## MEMORANDUM

SUBJECT: Facility planning review of Amherst Avenue Bikeway Study<sup>1</sup>

Re: Amherst Avenue Separated Bike Lane Alternatives

## Amherst Avenue Separated Bike Lanes Project – Alternatives Selection

*Figure 4: University Boulevard Intersection with Two-Way Separated Bicycle Lane Conflicts Shown*

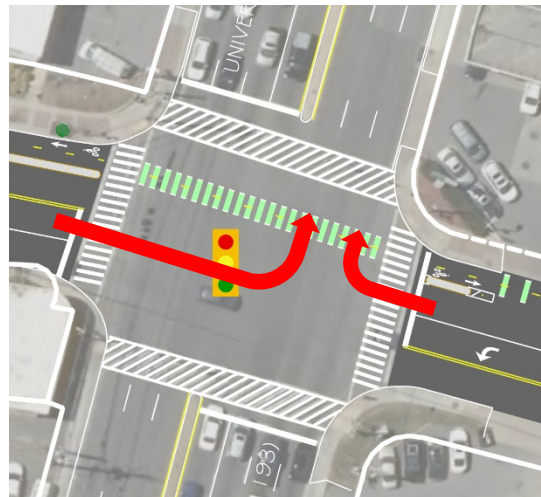
The success or failure of this project is directly tied to how safely bicyclists can cross the intersection of University Boulevard and Amherst Avenue.

As staff has discussed several times with the Planning Board, separated bike lanes do not end at the intersection. **In many ways, ensuring safe intersection crossings is more important from a safety and connectivity perspective than providing separation from traffic along a street segment.** Without spatial and temporal separation between bicyclists and motor vehicles at intersections, conflicts between bicyclists traveling through the intersection and turning motor vehicles cannot be substantially mitigated.

This is even more of a problem with two-way separated bike lanes because these bikeways facilitate bicyclist travel against the direction of motor vehicle traffic, which can be confusing for all road users. For example, a right-turning motorist crossing a bikeway may look over their right shoulder to see a bicyclist travelling in the same direction, but the motorist is less likely to consider that an oncoming bicyclist may be approaching (*Figure 4*). This conflict can be mitigated by separating turning vehicle movements from through bicyclists movements through signalization and roadway changes. **It is essential that this conflict be mitigated to create a safe bicycling environment.**

As a protected intersection is not currently included in the project alternatives at this location, a one-way bikeway (Alternatives 1 and 2) is safer than a two-way bikeway (Alternatives 3A, 3B, and 3B Modified) given the increased predictability and visibility of bicyclist travel in this configuration.

*Figure 6: Alternatives 1 and 2 between Blueridge Avenue and Arcola Avenue*

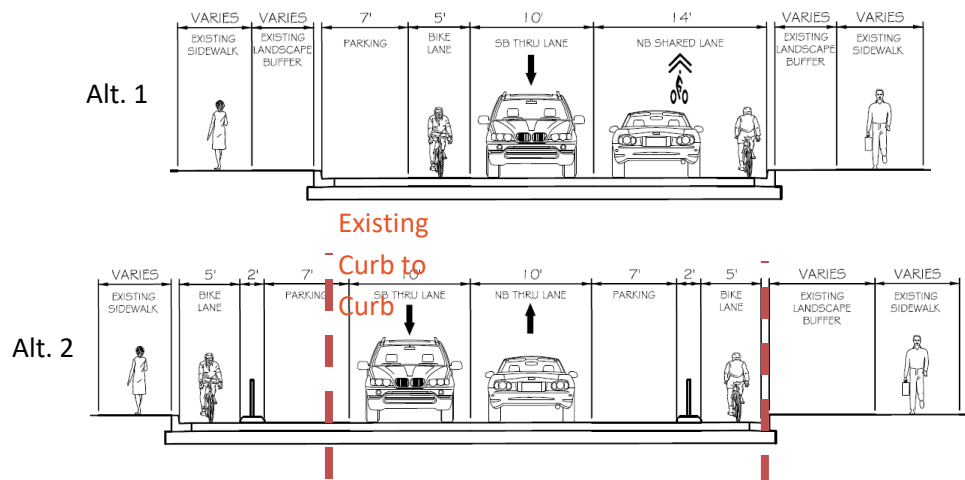
As discussed, MCDOT evaluated two one-way separated bike lane alternatives: Alternative 1 and Alternative 2. The two alternatives are identical in cross-section and in evaluation in Table 3, except in Segment 4 (*Figure 6*). Alternative 1 maintains the existing curb-to-curb width of the roadway to reduce project costs and street tree impacts. As a result, there would be no bikeway in the northbound direction (bicyclists would ride in traffic). In the southbound direction, a five-foot bike lane would be squeezed between a narrow seven-foot parking lane and a ten-foot travel lane. Conversely, Alternative 2 widens the road in this segment, which costs more and requires removing street trees, but adds space for two five-foot bicycle lanes with two-foot buffers from parking.

A shared lane as proposed in Alternative 1 will not be comfortable for the majority of bicyclists, due to the estimated AADT in this segment (approximately 6,700 vehicles per day) and a 25-mph posted speed limit. The Bikeway Selection Chart from the *Montgomery County Bicycle Master Plan Framework Report* (page 33) (*Attachment 4*) provides more information on the breakpoints between AADT and vehicle speed where different types of bikeways are appropriate.

Both alternatives include a northbound conventional bike lane between Pritchard Road and Reedie Drive. In this block with traffic volumes around 4,500 vehicles per day, a conventional bike lane is more acceptable, though not preferable (*Attachment 4*).

Figure 7: Alternative 2 by Segment

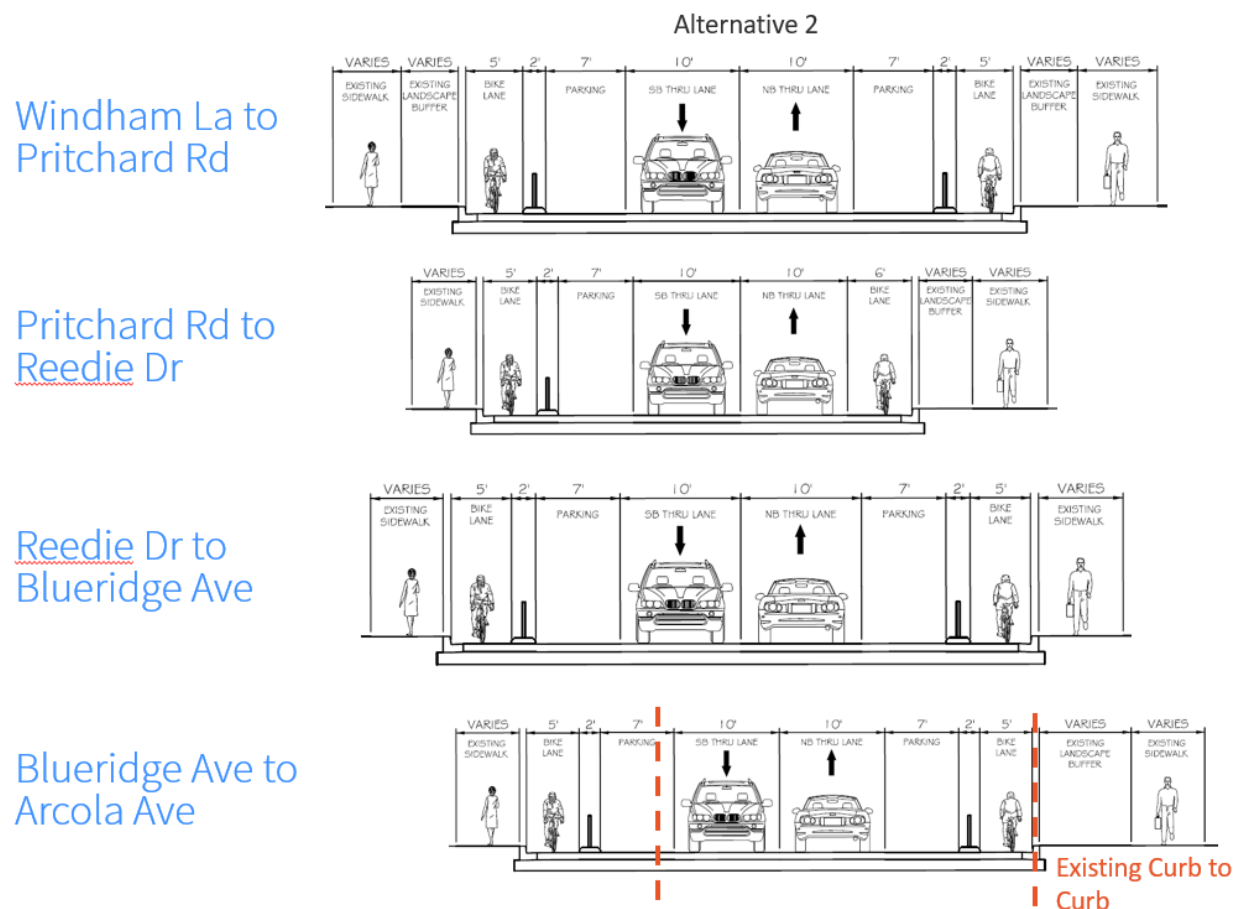
Of the two alternatives, Alternative 2 (*Figure 7*) is better because it provides a bikeway that will encourage more people to bicycle in this corridor. Neither of these one-way alternatives achieve the full vision of the Bicycle Master Plan. If this alternative is selected, staff believes that MCDOT should evaluate additional changes to the segment between Pritchard Road and Reedie Drive to provide a

separated bike lane in the northbound direction and to widen the buffers to 3 feet. Options include widening the roadway further, removing a parking lane or making this block a one-way road. If this alternative is pursued, staff would recommend that the options be resubmitted to the Planning Board for their review.

*Figure 8: Alternative 3A Cross-Section from Pritchard Road to Reedie Drive*

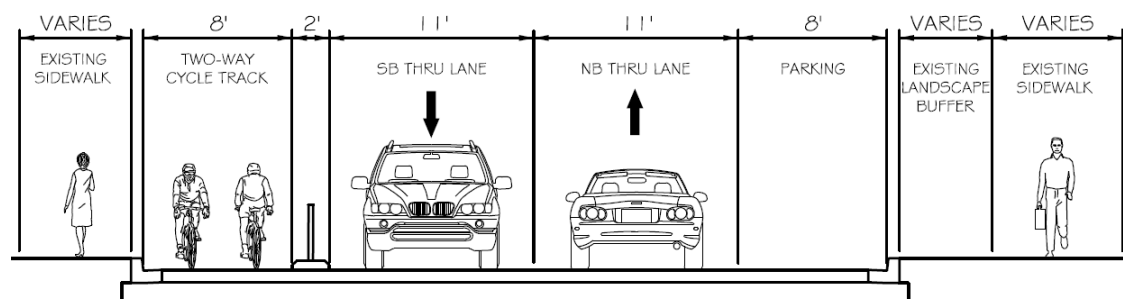
The remaining segment between Pritchard Road and Reedie Drive is different across the three two-way separated bike lane alternatives. This is a block that has long-term metered parking on the west side that residents of the adjacent townhomes can use at preferential rates. The parking utilization study for this project found that 88% of the west side's 32 parking spaces were occupied at any given time. The parking on the east side of the street is residential permit parking for the Wheaton Forest neighborhood. Alternative 3A removes the parking on the west side of this block to provide the two-way separated bike lane. The same parking study found that 50% of the east side's 25 parking spaces were occupied at any one time.

Alternatives 3B and 3B Modified keep both parking lanes by widening the road. Alternative 3B maintains the western curb line and widens the road on the east side, removing the existing landscape buffer, but keeping the existing sidewalk intact. Alternative 3B Modified does the opposite, holding the eastern curb line while expanding the road into the street furniture zone and sidewalk on the west side of the street. As described earlier, this reduces the sidewalk width on the west side from ten feet (seven feet at light poles) to eight feet (five feet at light poles). The road widening contemplated by Alternatives 3B and 3B Modified in this segment increases the cost of the project and its impacts on utilities, lighting, and the pedestrian environment. Staff believes that over the entire corridor, Alternative 3B Modified is the best two-way alternative, but between Pritchard Road and Reedie Drive, there are opportunities to save additional cost and limit impacts by modifying the Alternative 3A cross-section (Figure 8).

*Figure 9: Flipped Parking Option*

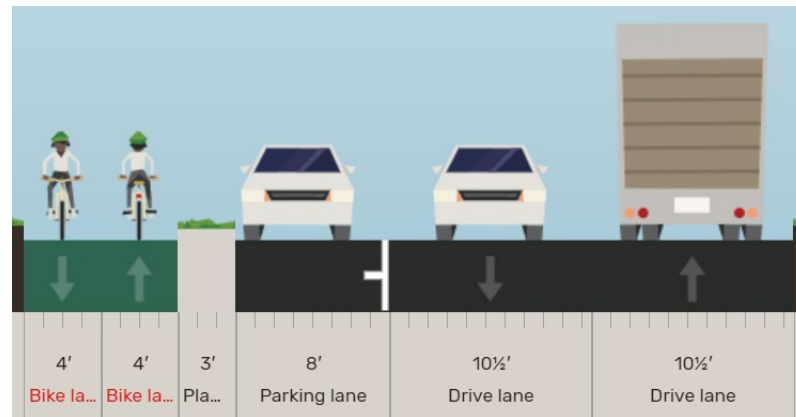
This modification, shown in Figure 9, narrows lanes to ten and a half feet and moves the on-street parking from the east side to the west side of Amherst Avenue. This option provides a three-foot buffer and uses the on-street parking to provide additional separation from traffic for the bikeway, while not requiring any costly curb changes.

Of the two-way bikeway alternatives, staff therefore recommends the Board support Alternative 3B Modified, but with a cross-section between Reddie Drive and Pritchard Road as shown in *Figure 9*.

Figure 10: Recommended Alternative

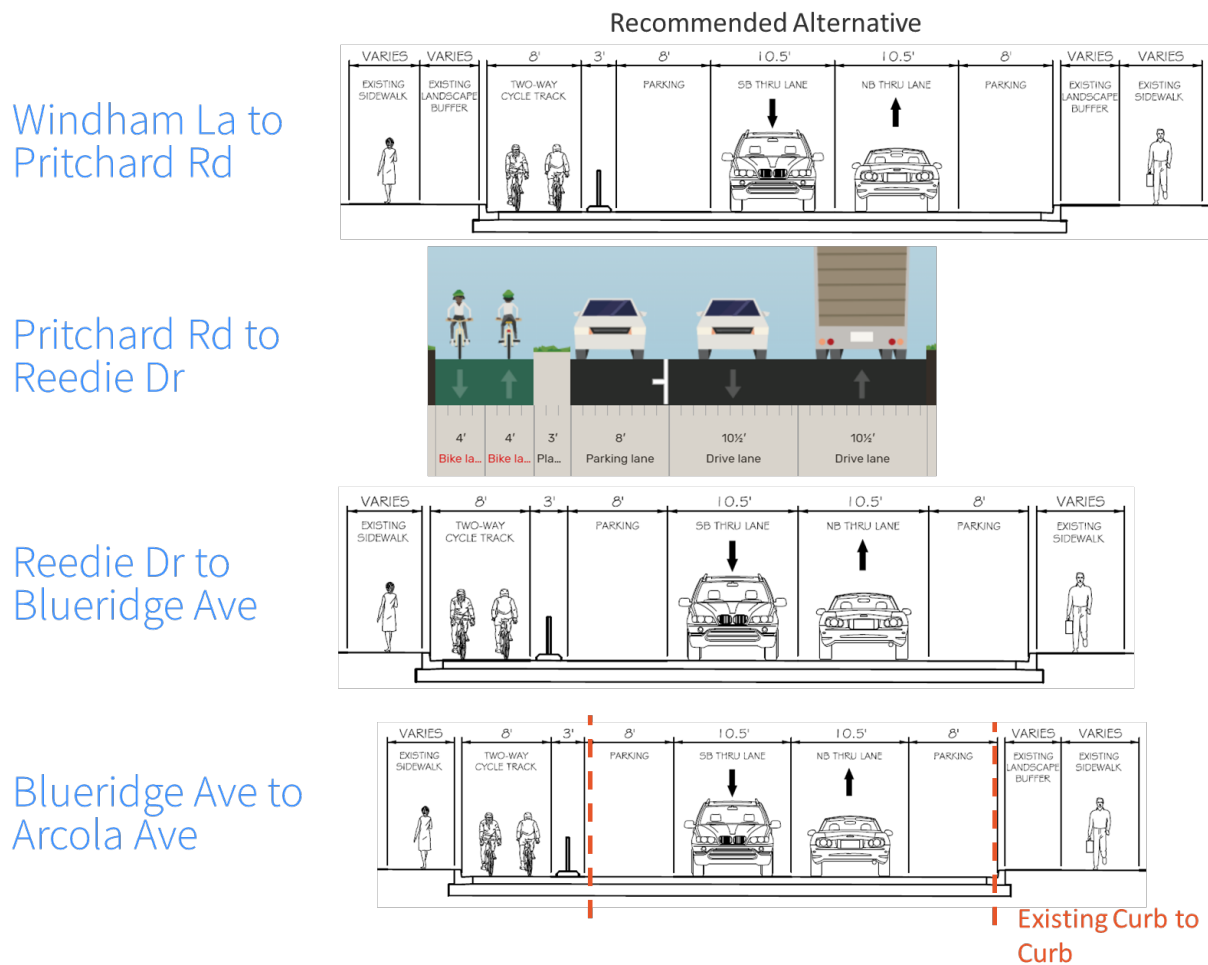
Given the limitations of this corridor, the change recommended to Segment 2 in Alternative 3B Modified will be lower-cost with fewer impacts than Alternative 2 while providing a comparable low-stress

experience to people bicycling along this corridor. The only hesitation staff has about recommending this alternative whole-heartedly is the uncertainty surrounding the University Boulevard intersection. Without appropriate bicycle signalization and roadway improvements, it may not be possible to address the safety issues inherent in a signalized two-way bikeway crossing.

1. **Advance Alternative 3B Modified as the preferred alternative if the Maryland State Highway Administration (SHA) approves a protected intersection at the intersection of University Boulevard and Amherst Avenue, to ensure a safe crossing for bicyclists using the two-way separated bike lanes. Additionally, between Pritchard Road and Reddie Drive, rather than widening the road, travel lanes should be narrowed to 10.5 feet and the parking lane should be moved to the west side of the street to provide a three-foot bikeway buffer with parking protection.**

2. **If this protected intersection is not approved by SHA, advance Alternative 2 as the preferred alternative and consider design changes to improve bicyclist comfort between Pritchard Road and Reddie Drive, potentially including roadway widening, removal of both lanes of parking, or removal of one travel lane. After additional public engagement on these issues, MCDOT should resubmit this project to the Planning Board for deliberations on the appropriate bikeway treatment between Pritchard Road and Reddie Drive.**
